HEARINGS COMMITTEE AGENDA

1 ESPLANADE RESERVE WAIVER FOR SUB-2025-166, 41 SOPER ROAD AND 20 AND 21 HENDERSON STREET, WINGATUI

Report from Lianne Darby

20-21 Henderson Street, 41 Soper Road
Esplanade Reserve Details 26 June 2025

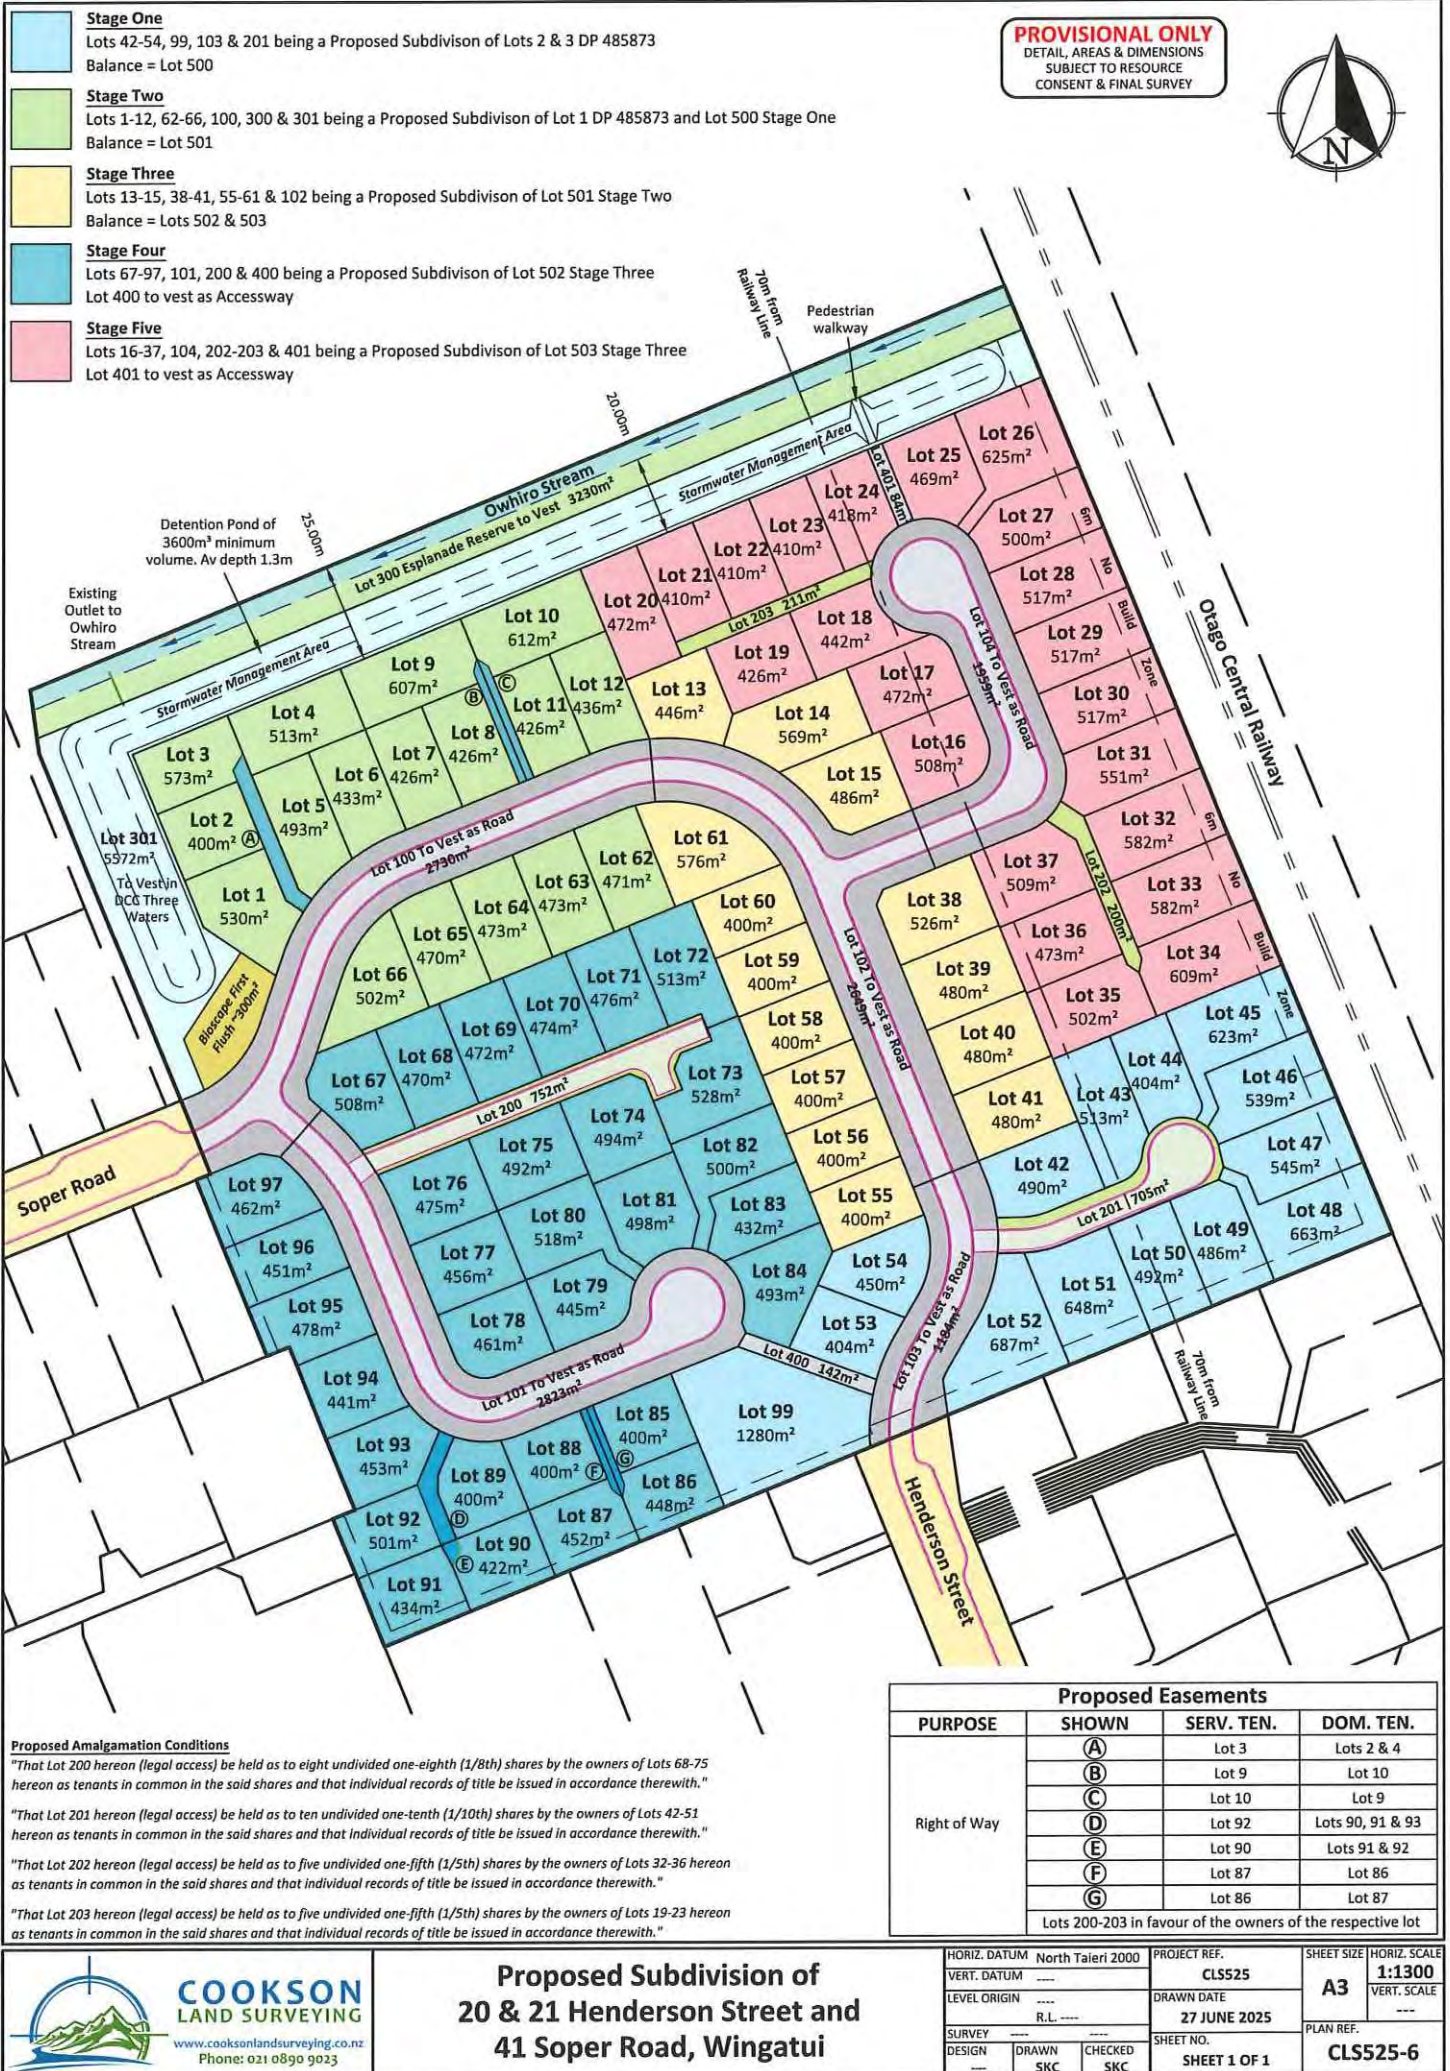
The Flood Protection Management Bylaw requires approval from the Otago Regional Council to plant a tree, shrub or hedge within 7.0m of the top of the bank of a scheduled drain. If the proposed esplanade reserve is to be 6.0m wide, then the bylaw restricts planting of the entire esplanade reserve unless approval is given by the Otago Regional Council. The Otago Regional Council has its own approval process for such works.

Returning to the subject of plantings, although the Bylaw is in place over the first 7.0m of land, it is likely that the Otago Regional Council will permit some vegetation within this area. The reduction of the esplanade reserve to 6.0m to 7.0m will, therefore, still result in vegetation along the edge of the stream although if there are to be taller trees included, the esplanade reserve will need to be wider. This will impact on the proposed stormwater management area.

Parks and Recreation Services seeks the full 20.0m of esplanade reserve to be set aside, and for the applicant to plant and maintain the area for three years. I note that planting within the 7.0m strip controlled by the Otago Regional Council (within the esplanade reserve as proposed) is likely to be acceptable although will be restricted in plant sizing. The planting of trees beyond 7.0m may not be of benefit to the biodiversity of the waterway until the trees are very large. Even then, the trees are unlikely to shade the stream given that they will be to the south of the waterway (and to the north of the nearby residential properties creating issues of another kind). Any esplanade reserve with new vegetation will enhance the existing situation. Parks and Recreation Services has recommended a number of conditions for consent for the creation of an esplanade reserve, with additional conditions recommended if the Committee is of a mind to grant consent to the reduction. Not all of these conditions are appropriate for a subdivision consent, and I have modified the recommended conditions accordingly.

5. *A planting plan and schedule must be submitted to the Council at rcmonitoring@dcc.govt.nz for certification by the Resource Consents Manager.*
6. *The applicant must obtain bylaw approval from the Otago Regional Council for any works, including planting, within the area identified as the East Taieri Drainage Scheme.*

7. *The applicant must plant the esplanade reserve with appropriate trees and shrubs set out in one of the Otago Regional Council's "Otago Native Planting Guides" appropriate to site, in*

accordance with the certified planting plan and schedule, and any requirements of the Otago Regional Council.
